DATE: July 25, 2025  
 TO: Paul Donaldson and Chris Johnstone, Cantiro  
 CC: Sheldon Gull, Tanvi Patel; Urban Systems  
 FROM: Jason Barta  
 FILE: 4265.0001.03-R  
 SUBJECT: Retaining Wall Design Change Rationale

SUBJECT: Retaining Wall Design Change Rationale

Figure 1 – Retaining Wall Guidelines from Zoning Bylaw 561, 2007

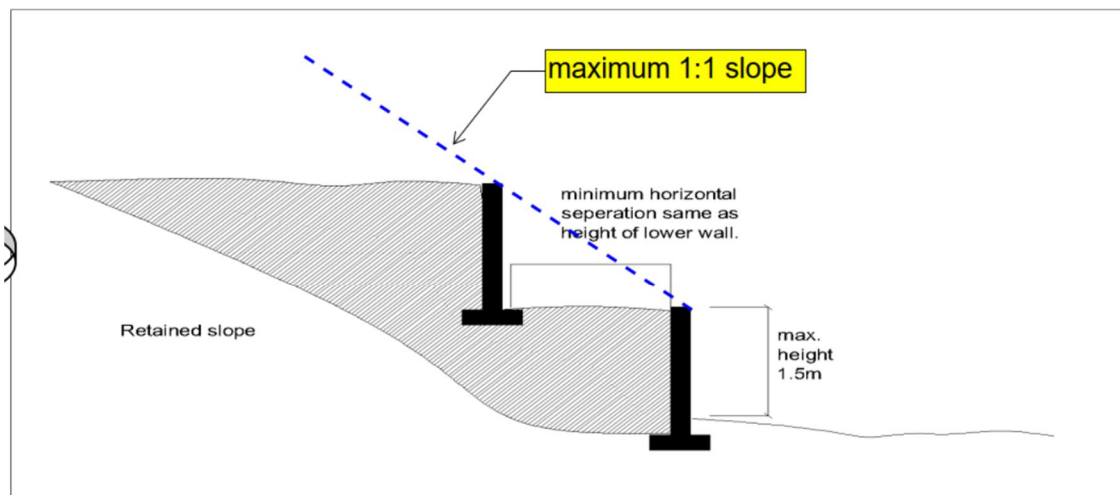
The District of Lake Country (District) has identified issues with the proposed design drawings for the retaining wall building permit. There are two main issues that the District has expressed to Cantiro and Urban Systems:

1. The overall slope of the tiered wall system exceeds the maximum 1:1 slope set out in the zoning bylaw.
2. There are more wall tiers shown in the 2024 Permit application than in the approved 2022 Development Permit (DP) package.

- 2025-06-27 District provides wall height calculation figure (refer back to Figure 1) and considers 2:1 slope between wall tiers as part of wall height, thus exceeding 1.5 meters maximum.

Figure 2 – Elevation Differences: 2022 DP vs 2024 Design

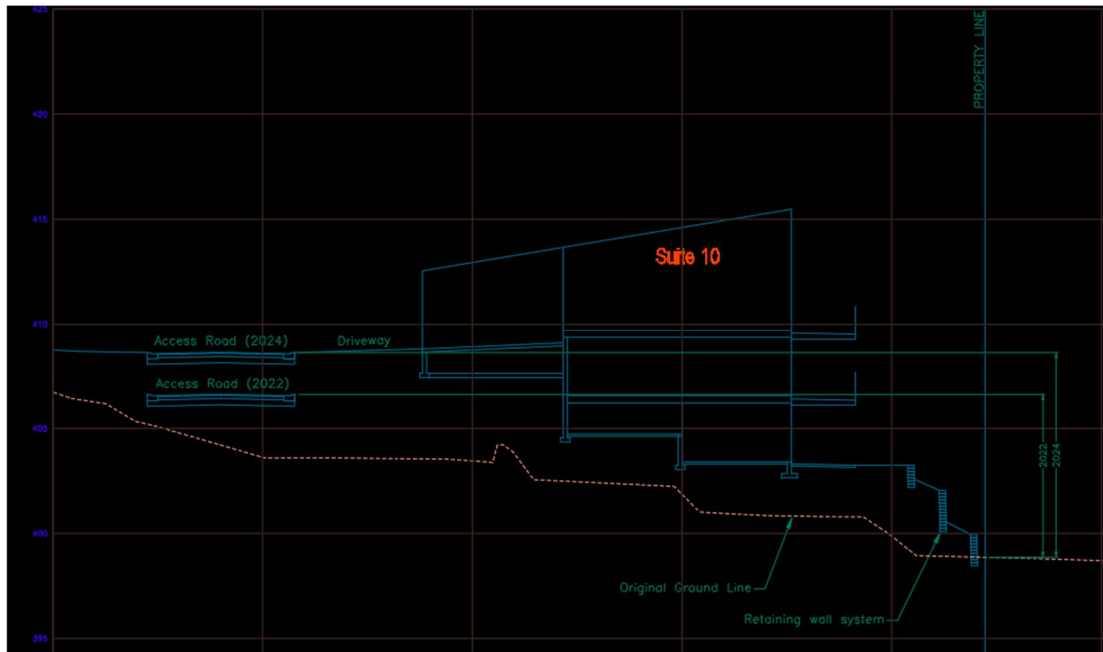
Retaining walls help bridge the elevation difference between the site access road and the ground line at the Rail Trail, at the west of the site. An example section is shown in the figure below.

The on-site road profile was raised in 2024 to accommodate the requirements of the Driveway Design & Construction Guidelines Policy 200, 2022. The two elements that governed the road profile were:

- The maximum roadway grade, and
- The grades around the modified hammerhead turnaround.

The Driveway Construction Policy and SDS Bylaw also required that the grade along the eastern leg of the modified hammerhead be kept as flat as possible – in this case 3% was used.

The two factors above limited the rate at which the site access road could slope down from Evans Road to the lowest point of the internal roadway. These factors raised the access road profile by as much as two (2) meters and required significantly more fill under the roadway and buildings. As the maximum wall height is restricted to 1.5 meters, the grade change of 2 meters would require at least"

Figure 3 – Retaining Wall Average Slope – Current Design

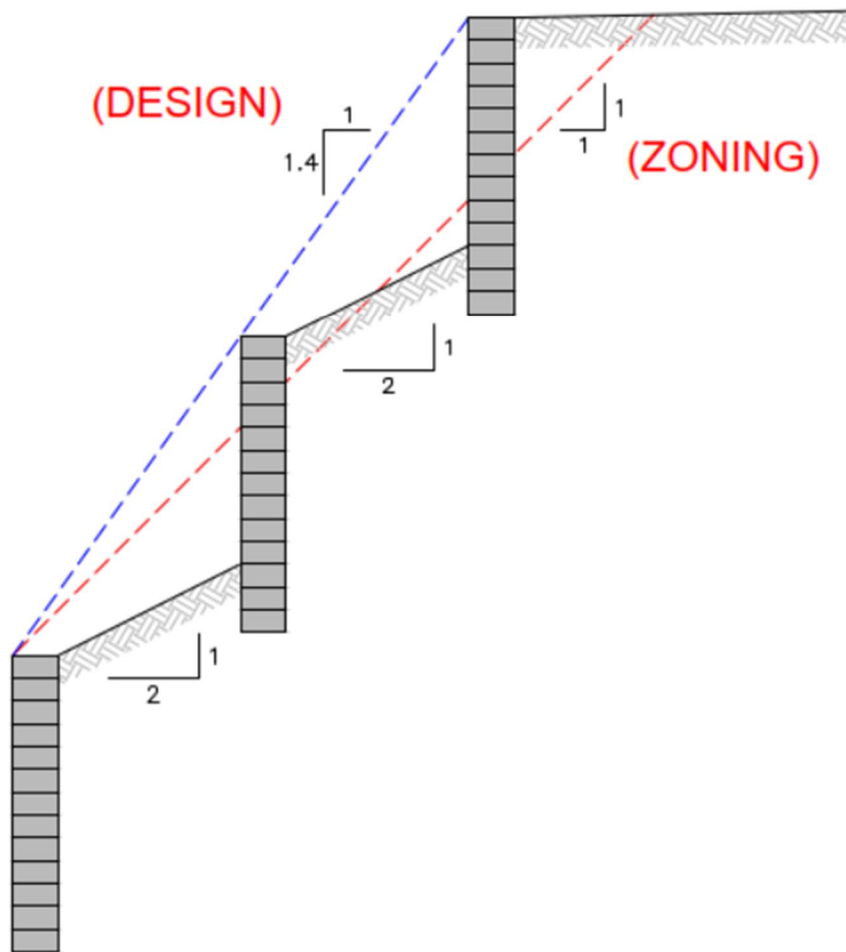
The figure below illustrates the overall slope (1.4h:1v) of the 2024 design compared to the zoning bylaw maximum of 1h:1v.

Spacing the wall tiers further apart to align with the maximum 1h:1v slope would further reduce the backyard space by at least 1.2 meters, beyond to 1.5 to 3.0 meters lost because of the higher road profile.

Figure 4 - Retaining Wall Average Slope - Alternate 2 Tier Design

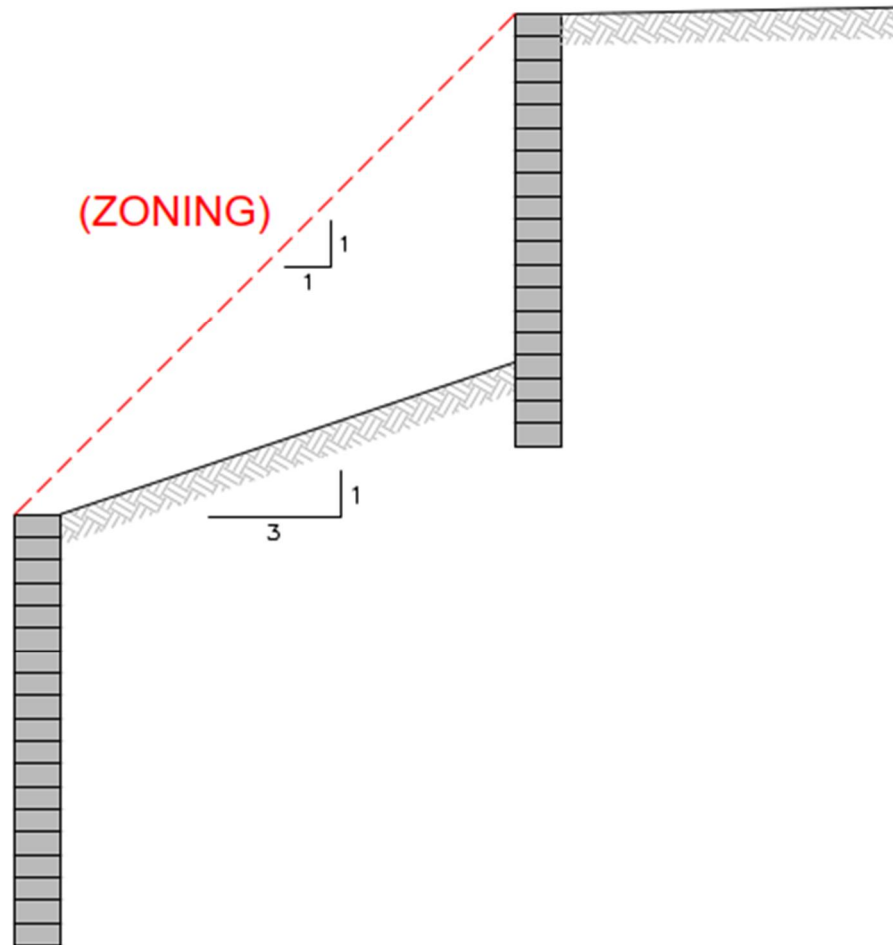
As an alternate option, a two-tiered wall design could be employed, though this would require a wall height variance to bridge the same elevation difference as the 3-tiered design. Figure 4 below illustrates.

In the example above, the exposed wall height would be approximately 2.4 meters in height, which is 0.9m more than the current maximum allowable wall height set out in the bylaw. Due to the increased wall height, the depth of the wall is only 0.3 meters more than the current 3-tiered design.

**OWL'S NEST DEVELOPMENT ON-SITE DESIGN**  
DETAILS  
RETAINING WALL CONCEPTS

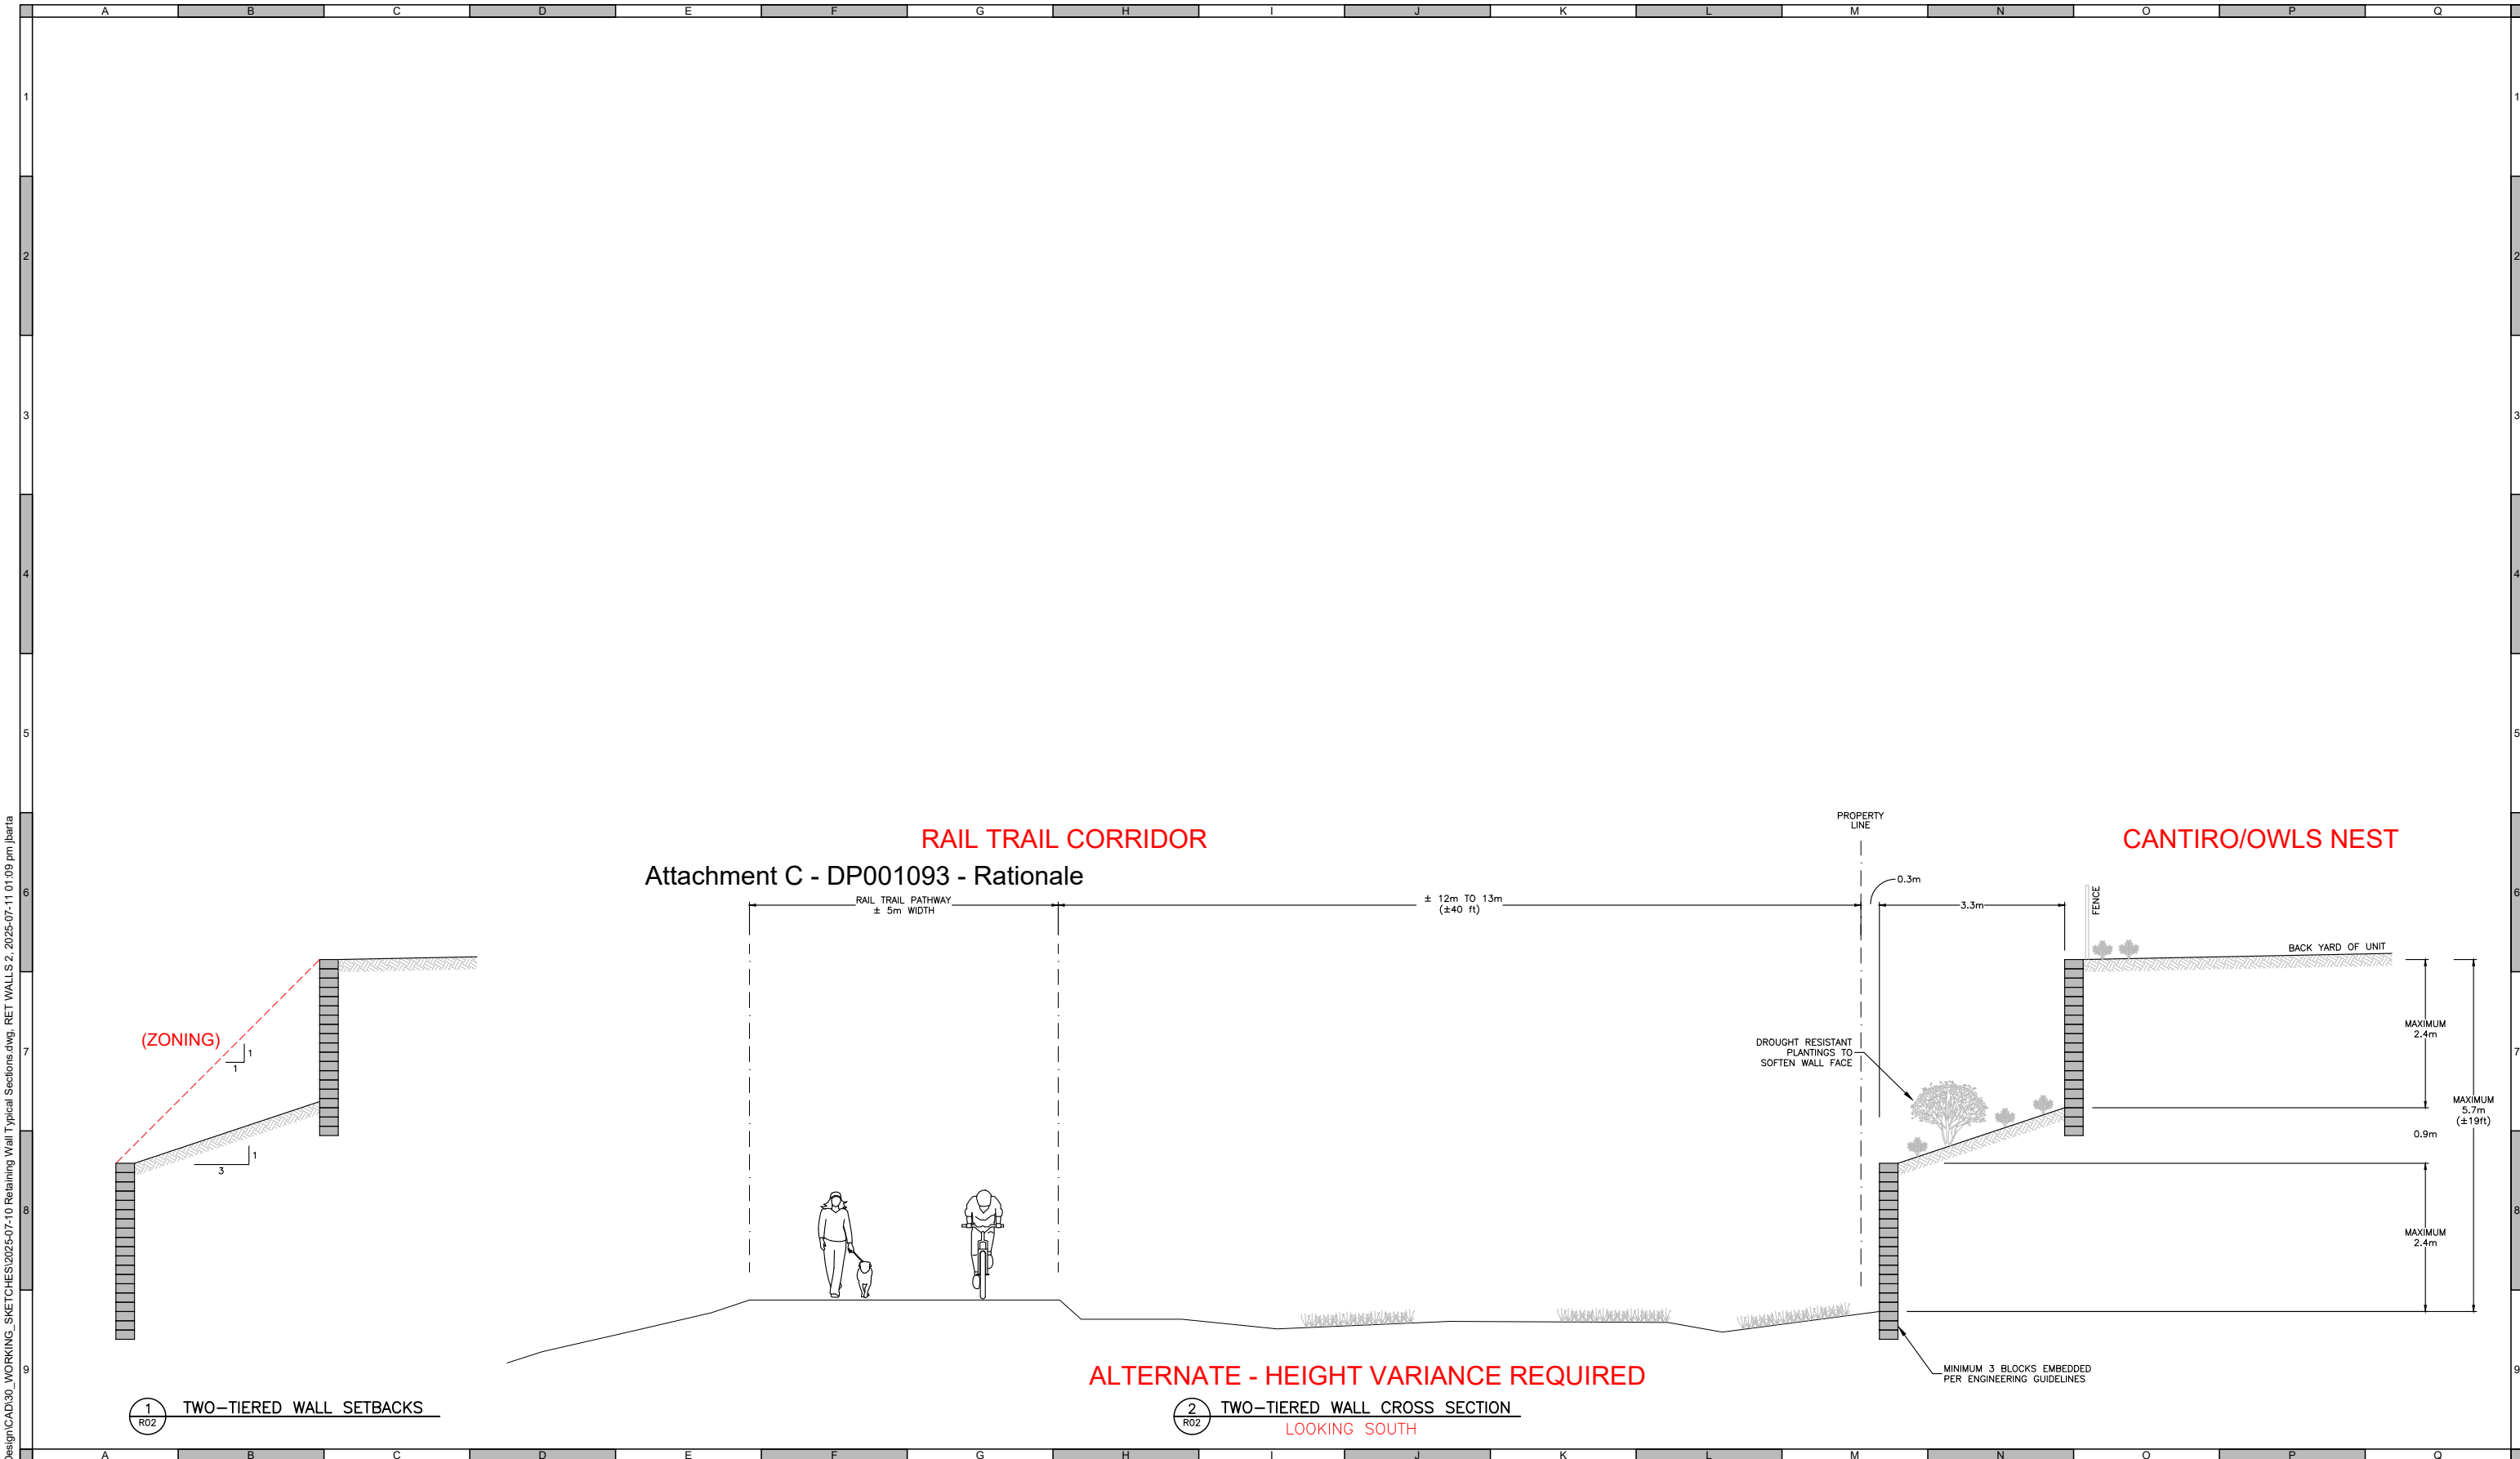
Appendix D illustrates the worst case (3-wall tiers) cross section between the Rail Trail and Development site as well as potential planting concepts to "soften" the wall appearance. This should help the reader understand the form and character of the low side of the development, along with the renderings that Cantiro is preparing. There is also a 2-tiered wall option at the same worst case location, that requires exposed wall heights of more than 1.5 meters, which would require a variance.
